Product Support Bulletin 2007-012

Maintenance of Way ~ Work Equipment Bulletin

DATE:	November 17, 2007		
SUBJECT:	Defective Aluminum Turntable Base Recall – 15138881		
RATING:	X DIREC	CTIVE n is required)	ALERT (Potential Problem)
		RMATION n is optional)	(Enhance Product)
MACHINE MODEL(S):		CX Hammer Anchor Applicator Model F	
SERIAL NUMBER(S):		All machines with Aluminum Turntable Bases	
SUMMARY:		The Aluminum Turntable Bases, p/n 15138881, supplied in 2007 have insufficient welds on the center tube support gussets and are being recalled. See Figure 1 on Page 2. The defective Aluminum Turntable Bases have intermittently stitch-welded gussets as shown in Figure 2 on Page 2. Any Aluminum Turntable Bases with stitch-welded gussets, either supplied with machines or ordered as repair parts, are being recalled.	
OPERATIONAL IMPACT:		THESE ALUMINUM TURNTABLE BASES MAY FAIL WHILE LIFTING THE MACHINE, POSSIBLY RESULTING IN SEVERE INJURY OR DEATH.	
ACTION:		WELDED GUSSETS AND R TURNTABLE BASES FROM ATTEMPT TO REPAIR DEF FIELD.	ECTIVE TURNTABLE BASES IN THE

Figure 1 Aluminum Turntable Base p/n 15138881

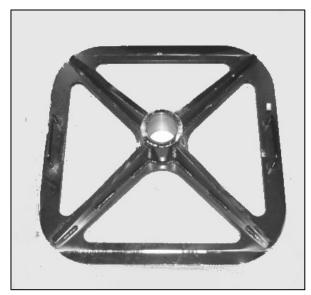
Only aluminum turntable base	s with stitch-welded gussets are affected

Only aluminum turntable bases with stitch-welded gussets are affected by this recall and must be returned to Nordco for replacement. Aluminum Turntable Bases with continuous welded gussets and Steel Turntable Bases are not affected by this recall.

WARRANTY: Aluminum Turntable Bases with stitch-welded gussets will be replaced under warranty. Contact the Nordco Service Department at 1-800-445-9258 to obtain a Goods Return number (GRFC). Please have the serial number of the machine(s) available when calling or the purchase order number in the case of replacement bases. Do not return any bases to Nordco without first obtaining a GRFC number.
